COMANCHE PEAK RESPONSE TEAM

QUALITY INSTRUCTION FOR ISSUE-SPECIFIC ACTION PLAN VII.c

CHANGE NOTICE: 001

REINSPECTION OF LARGE BORE PIPES SUPPORTS - NON-RIGID

C. Snubber Transition Kits (9C)

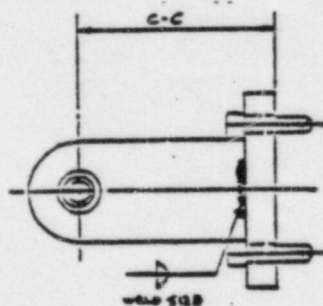
2. Replace Page 24 with the attached page.

For ITT Grinnell and NPSI Snubber Transition Kits, verify the following fillet weld sizes are met as a minimum:*

<u>Snubber Size</u>	1/4 - 1/2	1	3	10	35	100
<u>Weld Size</u>	3/16"	3/16"	3/16"	1/4"	3/8"	5/8"

*Weld sizes need not be larger than the thickness of the coupling.
